## 2.3 Radiation Monitoring Systems

The information in this section of the ABWR DCD, including all subsections, tables, and figures, is incorporated by reference with the following departures.

STD DEP T1 2.3-1 (Figure 2.3.1)

STD DEP T1 2.14-1 (Table 2.3.3)

**Figure 2.3.1 Process Radiation Monitoring System Control Interface Diagram**

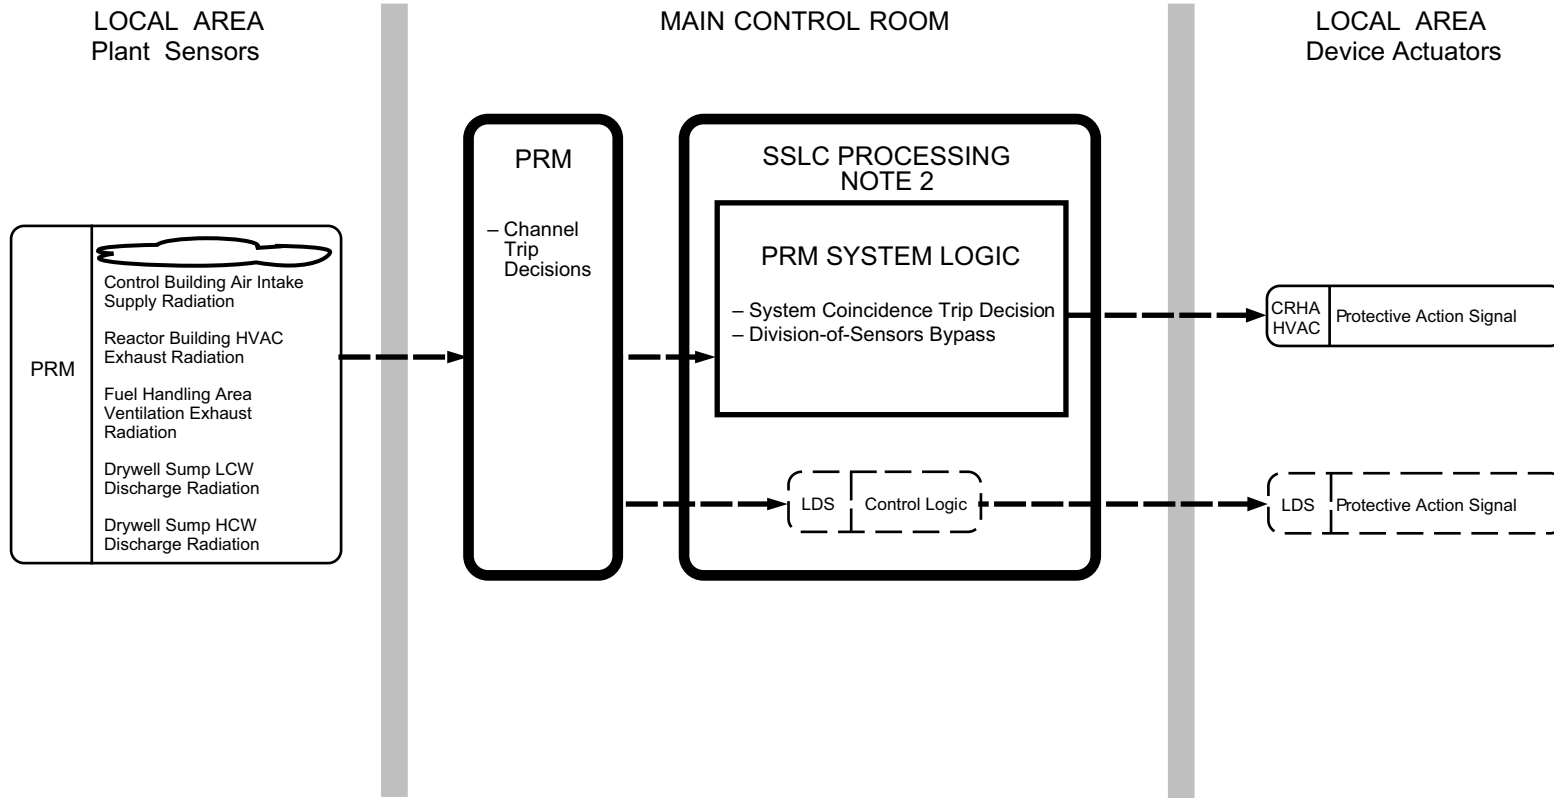
STD DEP T1 2.3-1

*The Process Radiation Monitoring (PRM) System measures and displays radioactivity levels in process and effluent gaseous and liquid streams, initiates protective actions, and activates alarms in the main control room (MCR) on high radiation signals. The PRM System provides radiological monitoring during plant operation and following an accident. PRM System equipment consists of radiation sensors, radiation process monitors, and effluent samplers. The PRM System consists of independent subsystems each of which contains between one and four monitoring channels. Figure 2.3.1 shows the PRM System control interfaces. As shown on Figure 2.3.1, the PRM System safety-related channel trip signals are provided as inputs to the Safety System Logic and Control (SSLC) for generation of protective action signals.*

*Portions of the PRM System are classified as Class 1E safety-related (items 42 through 5 below); the remainder are classified as non-safety-related.*
